MEMORANDUM FOR RECORD

SUBJECT: Water Street, Barboursville, WV Section 14 Emergency Stream bank Protection Project - Revision to Recommended Alternative in the approved Detailed Project Report.

Figure 1. Recommended Plan as documented in the July 2017 Detailed Project Report

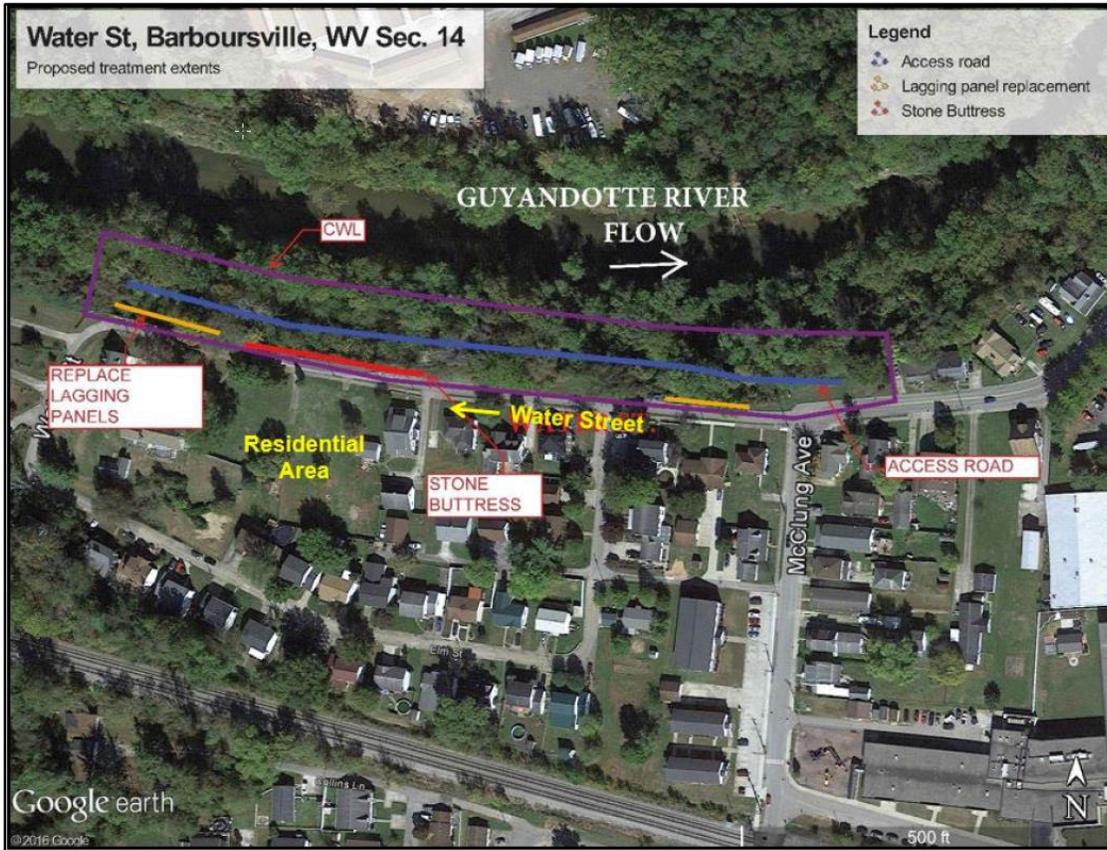
The original recommended plan consisted of a stone buttress and lagging panel replacement. In February 2019, the Project Delivery Team recommended modifying the plan to consist of replacing the stone buttress with two sections of wall comprised of H-pile and lagging with anchoring, two sections of lagging replacement, and armoring of a storm drain outfall.

Due to new information from soil borings, the site was determined suitable to support a stone buttress instead of the wall and anchor system. The proposed project construction consists of, limited, benched excavation of failed soils to stable foundation geometries, the placement of filter and reinforcement fabric under 24" stone with a toe of slope key in in two areas adjacent to Water Street. The upstream extents of construction are approximately 280 linear feet and downstream extents at the Water Street and McClung Ave. intersection are approximately 160 linear feet. Wooden lagging will be replaced in one section of the project area. Illustrations depicting the plan view of features of the original plan and the newly revised plan are included as an attachment to this memorandum.
